Title: <b>INSULATED - 500' - 4" PIPE</b>	PERMIT NUMBER: <b>ACT/007/007</b>
Description: <b>EMERGENCY -- AMENDMENT WILL BE SUBMITTED LATER</b>	PERMIT CHANGE #: <b>93Q</b>
	MINE: <b>SUNNYSIDE MINE</b>
	PERMITTEE: <b>SUNNYSIDE COAL</b>

# APPLICATION FOR PERMIT CHANGE

Title of Change:  Manshaft Pump Line/Culinary Water Line	Permit Number: ACT / 007 / 007
	Mine: Sunnyside
	Permittee: Sunnyside Coal Company

Re: Permit Amendment for Adding the Manshaft Pipeline to the  
001 Pond and Connecting all Mine Water Pipelines to an  
Existing Old Culinary Water Pipeline.

PLATE III-33 (11 OF 12)

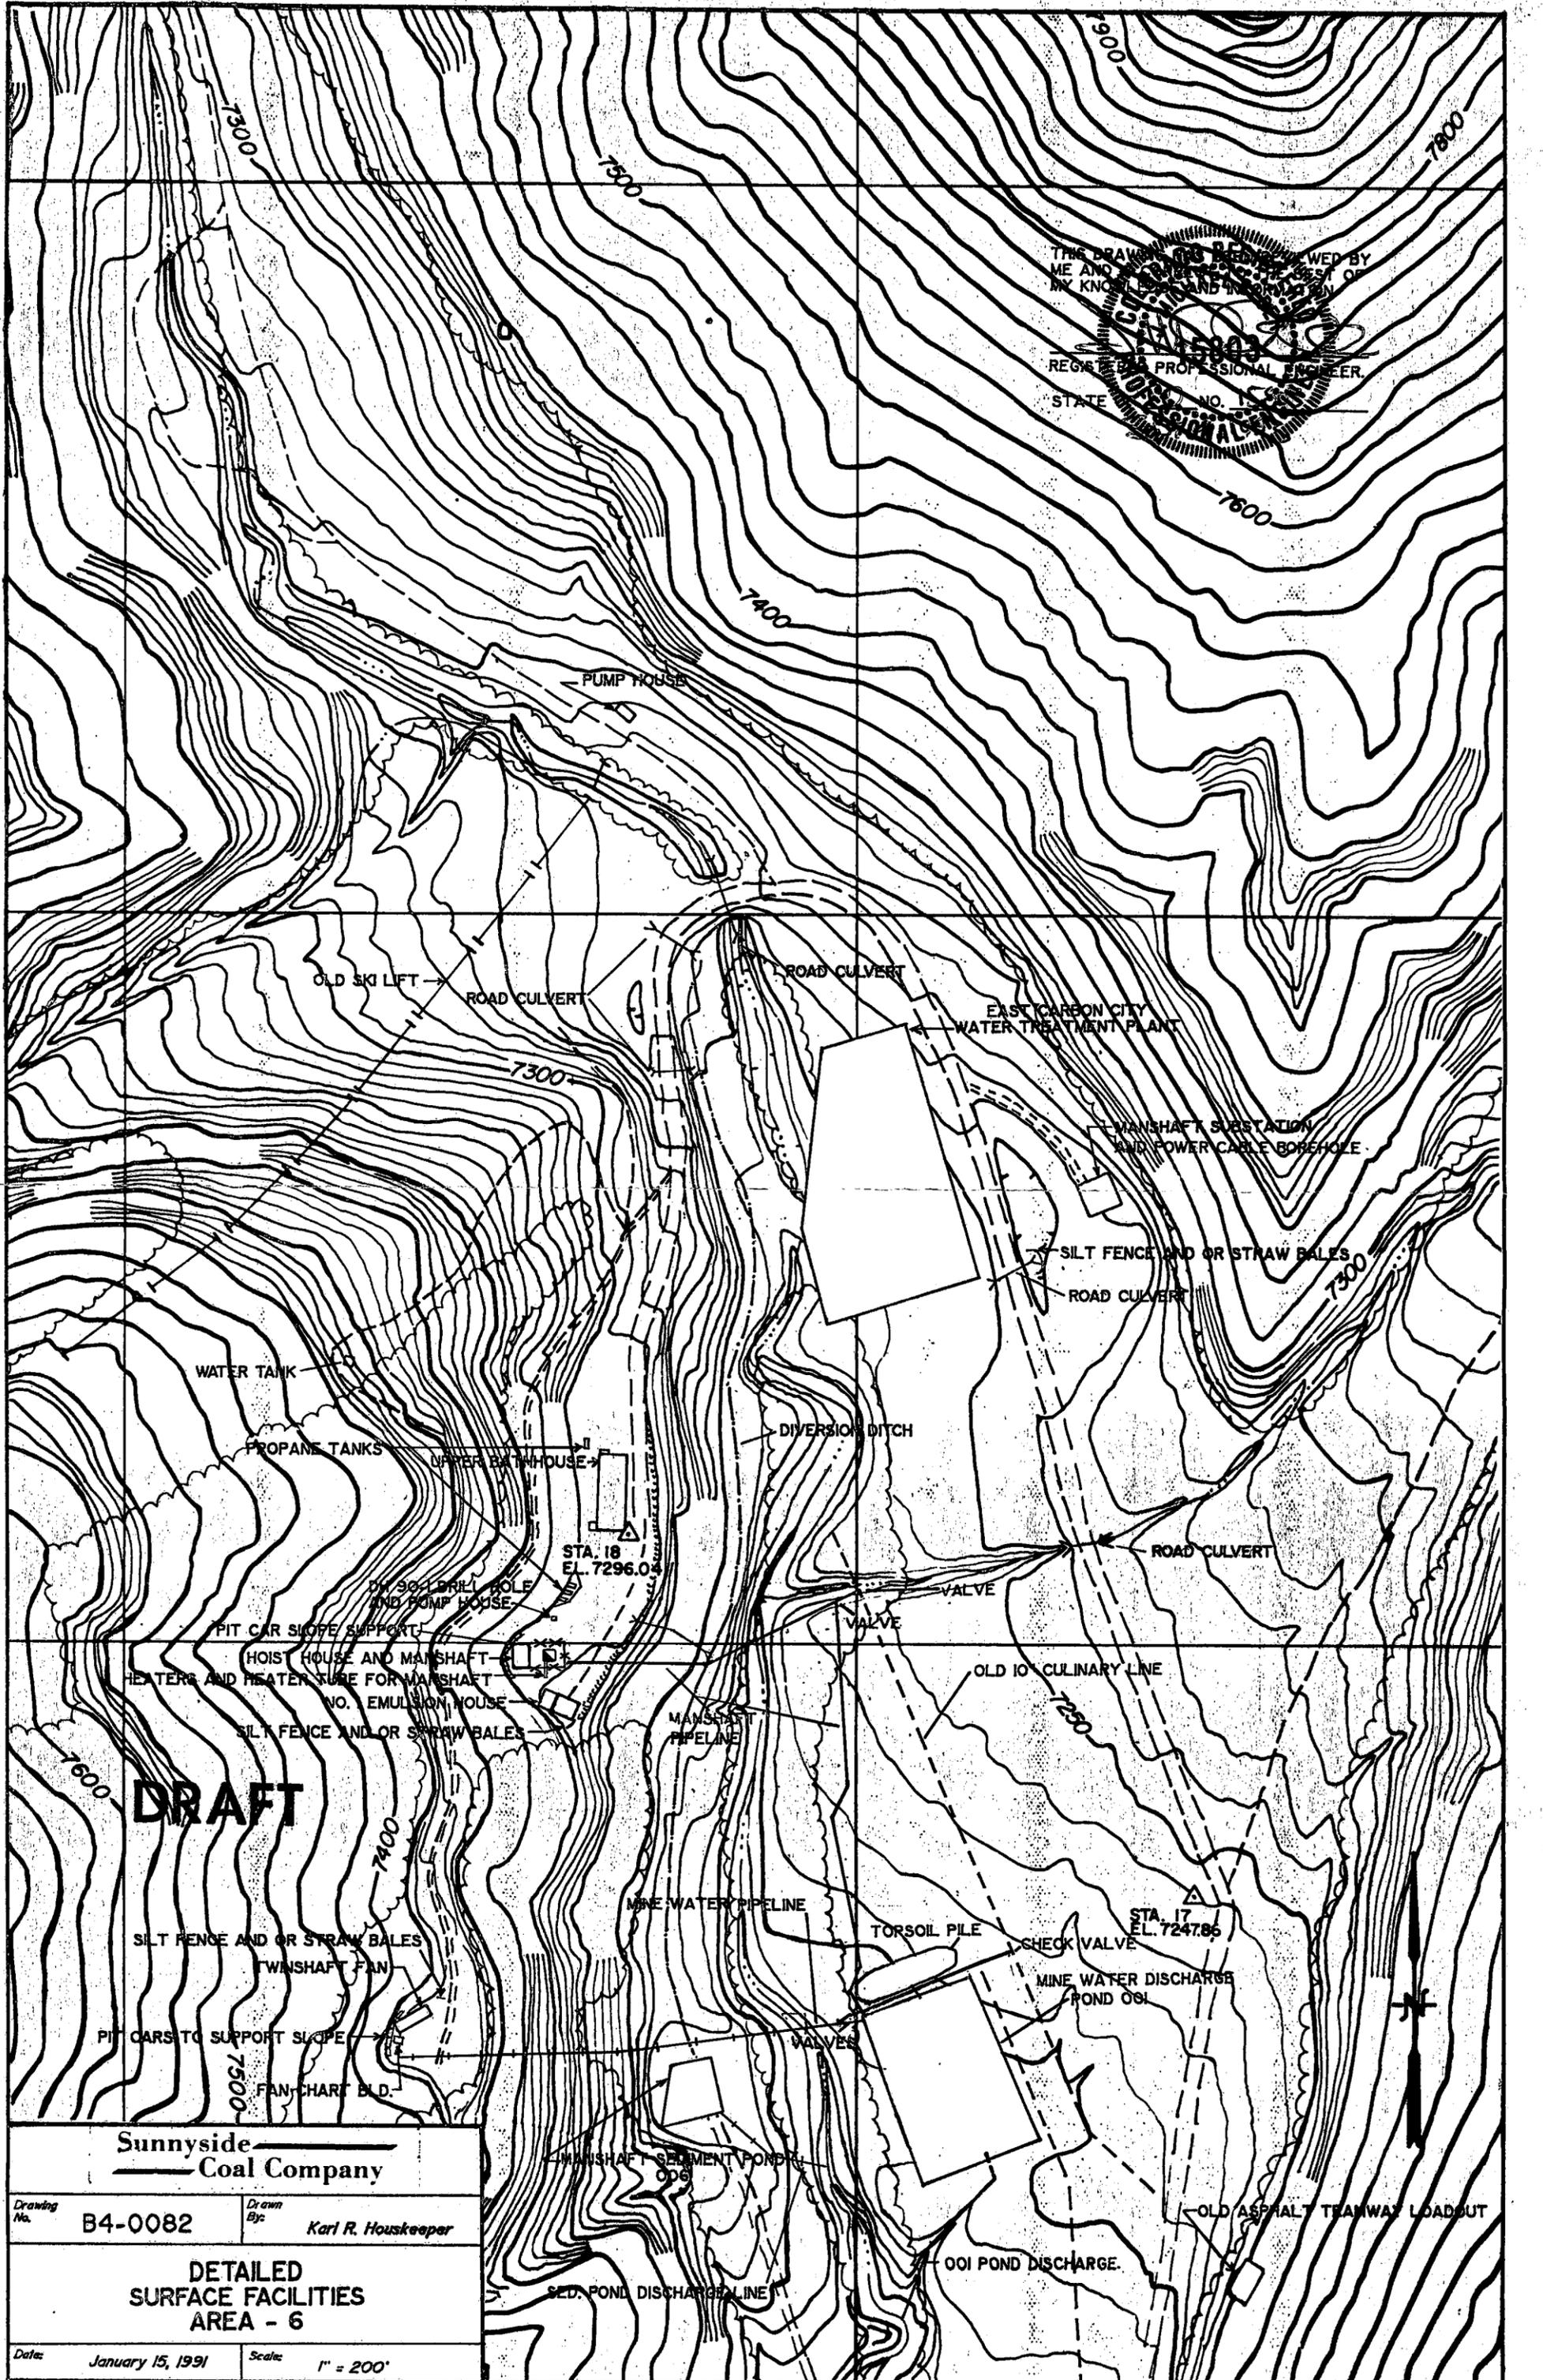
the surface, has been put back into service. The pumpline, which originally fed into the old 10" Culinary Water Line, has been routed to discharge into the 001 Mine Water Pond. The location of the Manshaft Pumpline is shown on Drawing B4-0082, "Detailed Surface Facilities Area - 6", and the location of the old 10" Culinary Water Line is shown on Plate III-16.

SCC has additional plans to attach the Manshaft Pumpline and the Twinshafts Pumpline to the old 10" Culinary Water Line, owned by the cities of Sunnyside and East Carbon and leased to SCC, in order to complete a system that will permit the diversion of mine water to any point on its property in order to allow for additional settling and treatment of mine water. Connections will be made from the Manshaft Pumpline and the Twinshafts Pumpline to the old 10" Culinary Water Line at the 001 Mine Water Pond (see Drawing No. B4-0081), and from the Culinary Water Line to the 002A and 002B Mine Water Ponds via a connection at the Whitmore Fan Return Air Shaft (see Drawing No. B4-0082). A valve installed at this connection will allow either the diversion of water to the 002A and 002B Ponds or continuation of flow through the 10" Culinary water line to the Twin Tanks. The location of the old 10" Culinary Water Line is shown on Plate III-16.<sup>1</sup>
